### **DEVIATION REQUEST** AND DECISION FORM

Project Name: Urban Collection at Palmer Village

A deviation from the standards of or in Section <u>Section 2.3.7.F.1 Curb Returns – Radii, Table 2-31</u> of the Engineering Criteria Manual (ECM) is requested.				
Identify the specific ECM standard which a deviation is requested:				
Table 2-31 states that the minimum curb return radii for a Local/Local intersection is 20'.				
State the reason for the requested deviation:				
This request is to utilize a minimum of 10' curb return radii throughout the development. The request is to better facilitate the site layout while allowing designated parking areas to meet requirements. See the Preliminary Plan in Attachment #2 for a layout of the development. The County criteria does not address alley/alley intersections, or any type of intersection with an alley.				
Explain the proposed alternative and compare to the ECM standards (May provide applicable regional or national standards used as basis):

SHEET **3** OF **10** JOB NO. **25149.01**

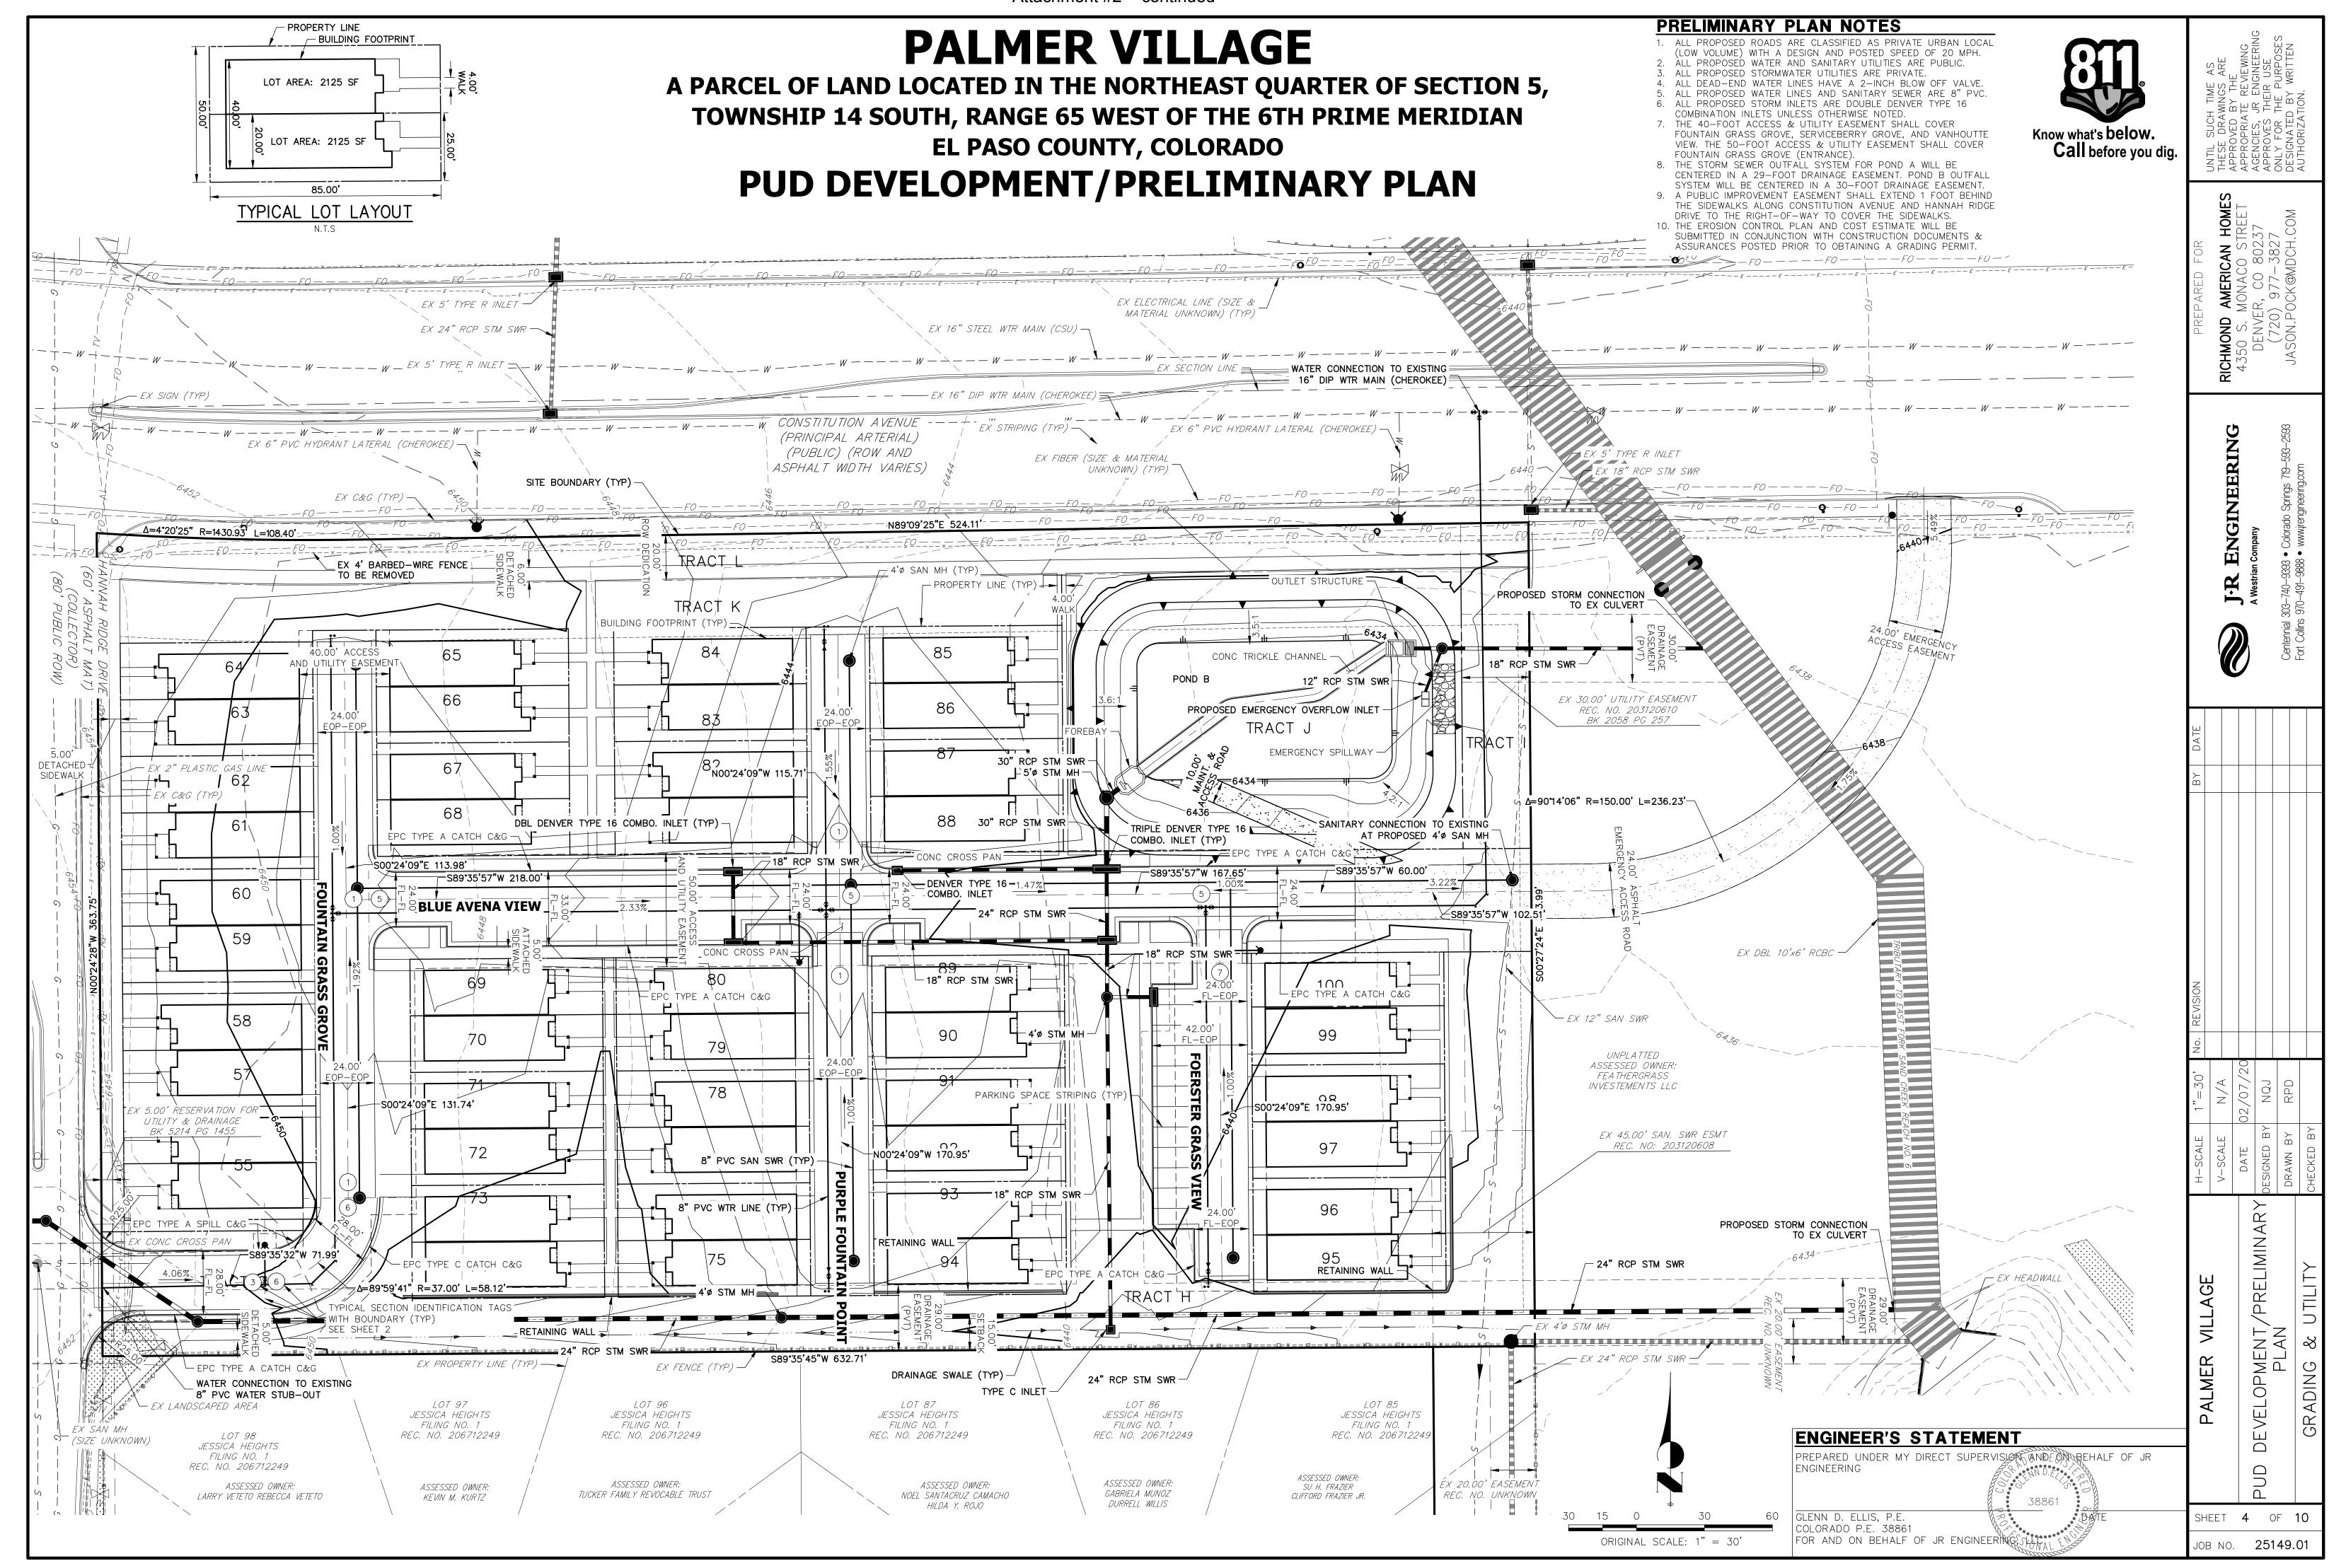
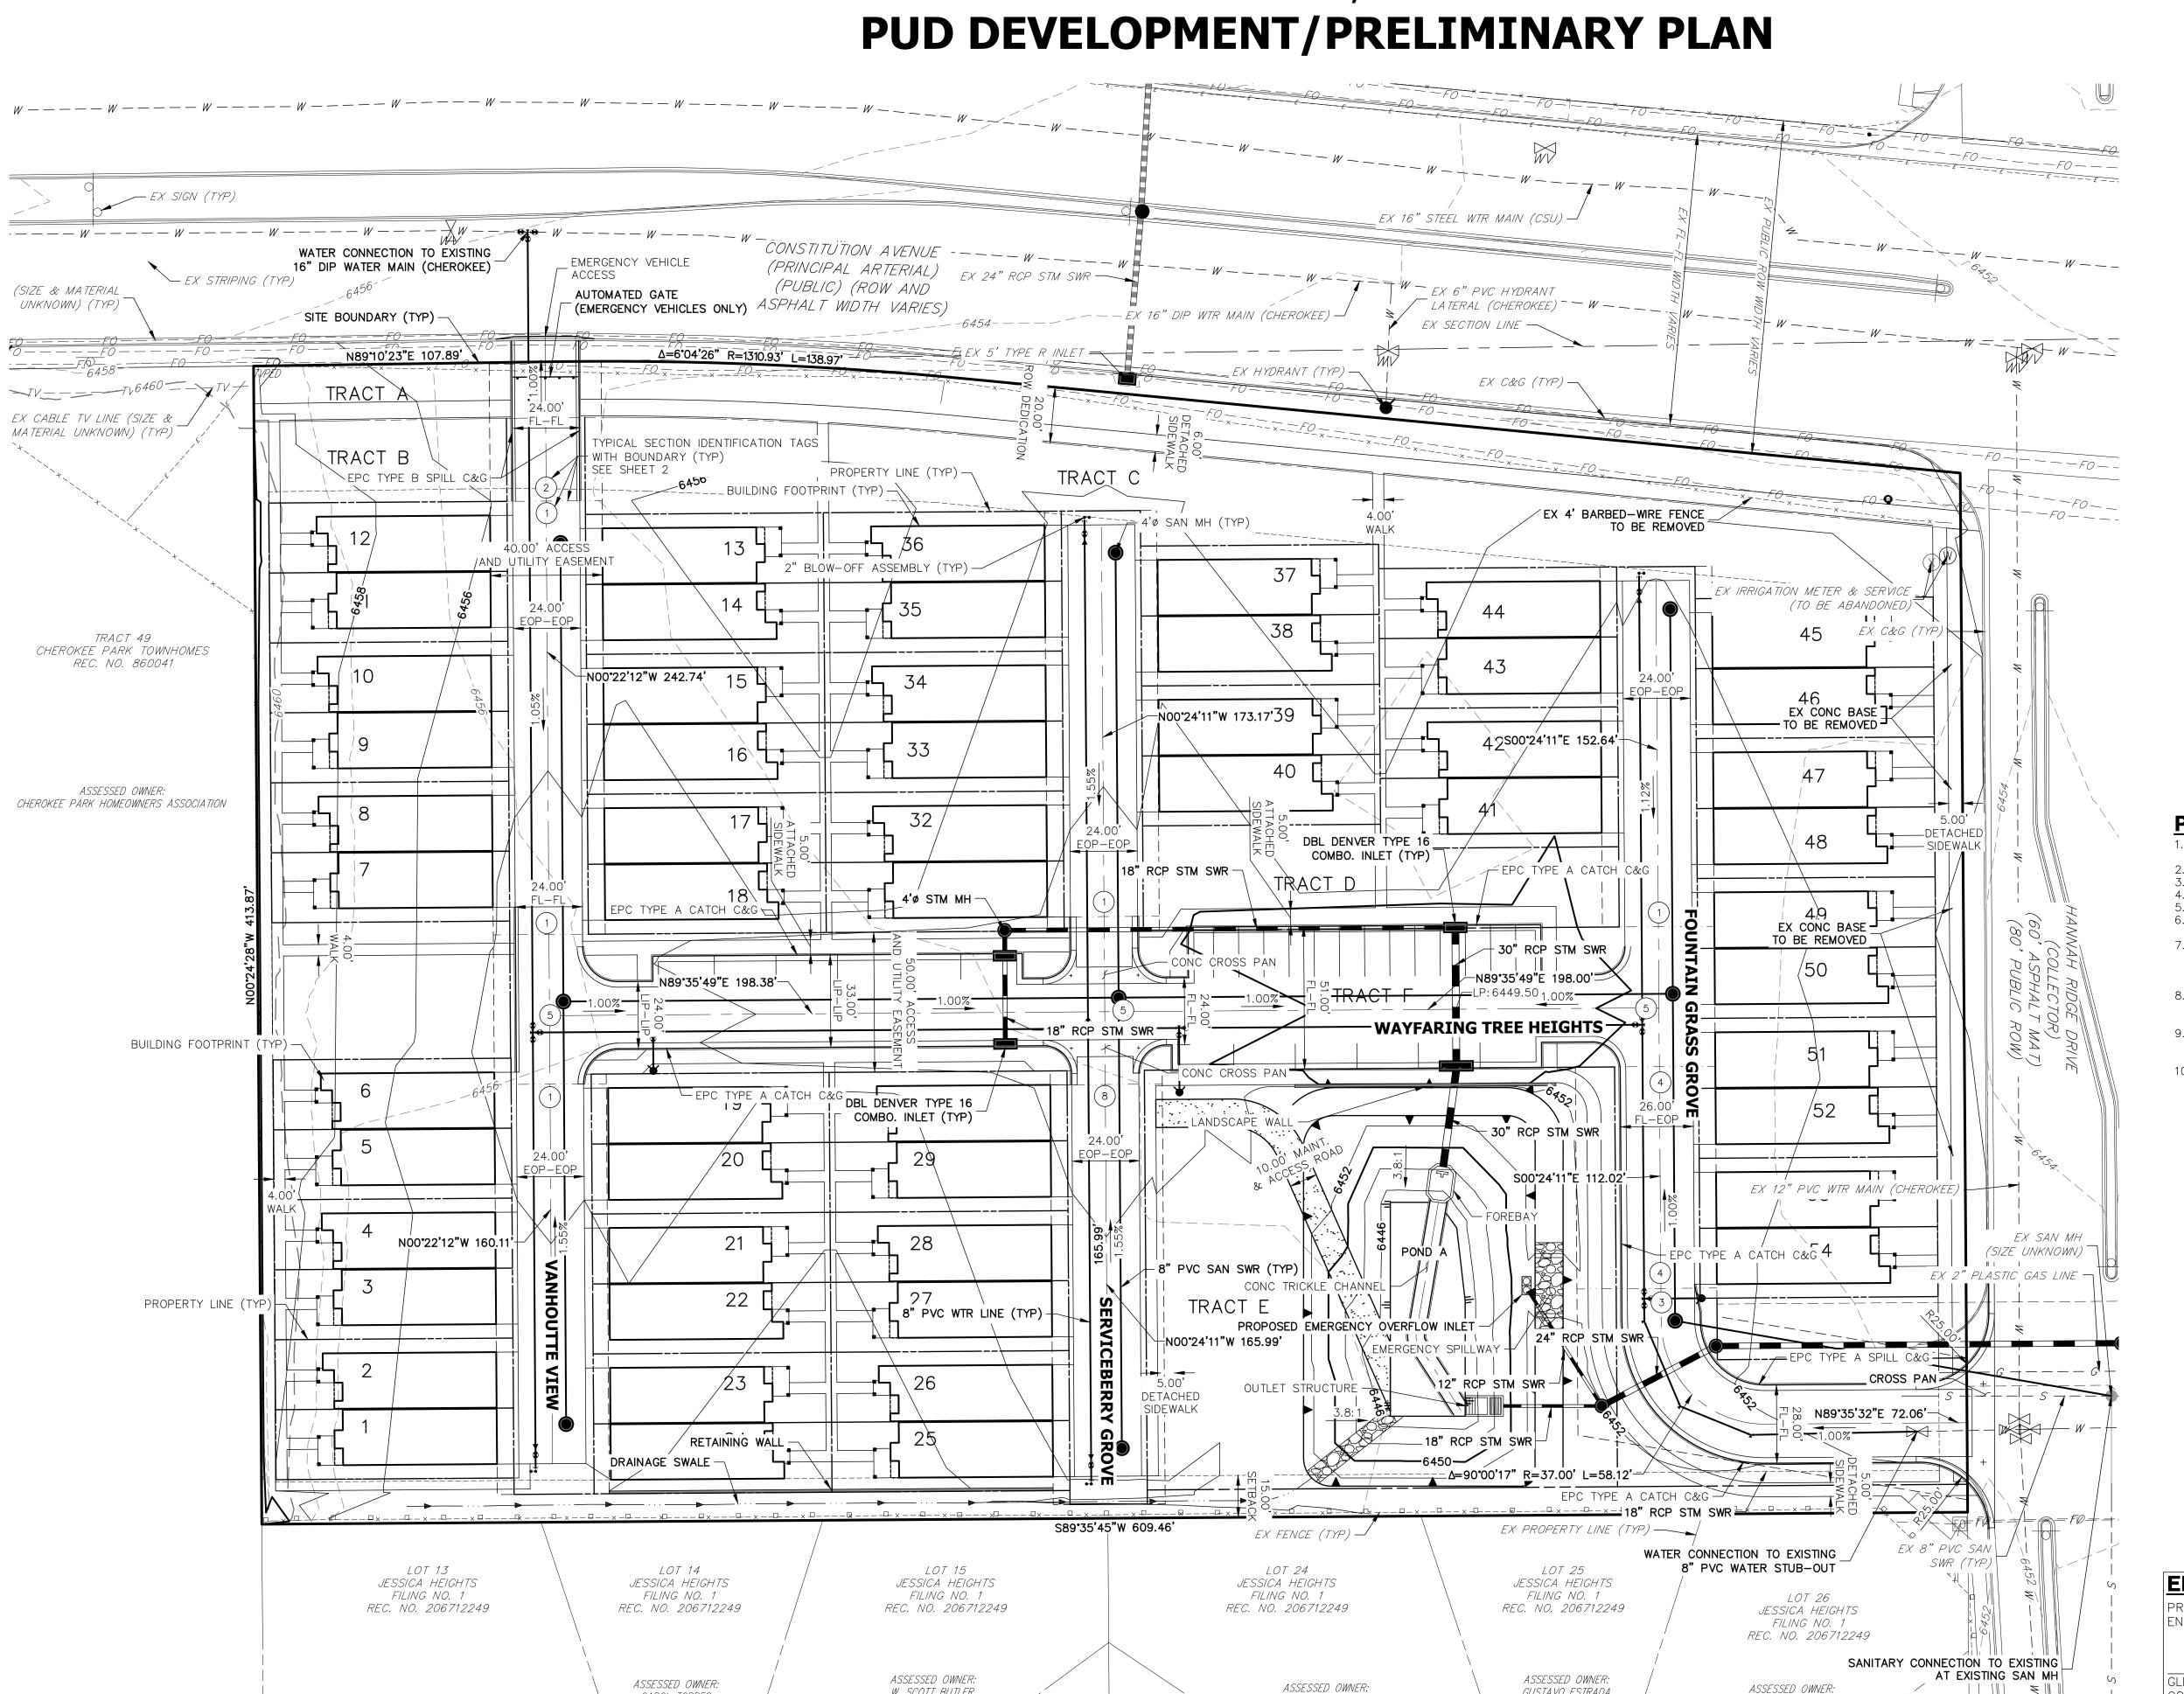
The entrances to the alleys (private) and along the main road (private) will have curb return radii of 10' instead of 20'.

(At least one of the conditions listed below must be met for this deviation request to be considered.)
<ul> <li>☑ The ECM standard is inapplicable to the particular situation.</li> <li>☐ Topography, right-of-way, or other geographical conditions or impediments impose an undue hardship and an equivalent alternative that can accomplish the same design objective is available and does not compromise public safety or accessibility.</li> <li>☑ A change to a standard is required to address a specific design or construction problem, and if not modified, the standard will impose an undue hardship on the applicant with little or no material benefit to the public.</li> </ul>
Provide justification:
The private roadway network of the development will function and be laid out as alleys off of Hannah Ridge Drive. The County criteria does not address alleys. The development requires parking for the units to be along the roadway, therefore the tighter radii will facilitate maximizing available parking areas.

CRITERIA FOR APPROVAL
Per ECM section 5.8.7 the request for a deviation may be considered if the request is <b>not based exclusively on financial considerations</b> . The deviation must not be detrimental to public safety or surrounding property. The applicant must include supporting information demonstrating compliance with <b>all of the following criteria</b> :
The deviation will achieve the intended result with a comparable or superior design and quality of improvement.
Access into the alleys (private), and through the intersections will not be impeded by the reduced curb return radii.
The deviation will not adversely affect safety or operations.
The reduced curb return radii will not adversely affect safety or operation. The reduced radii will facilitate slower speeds and require increased awareness by motorists entering or leaving an intersection (alley).
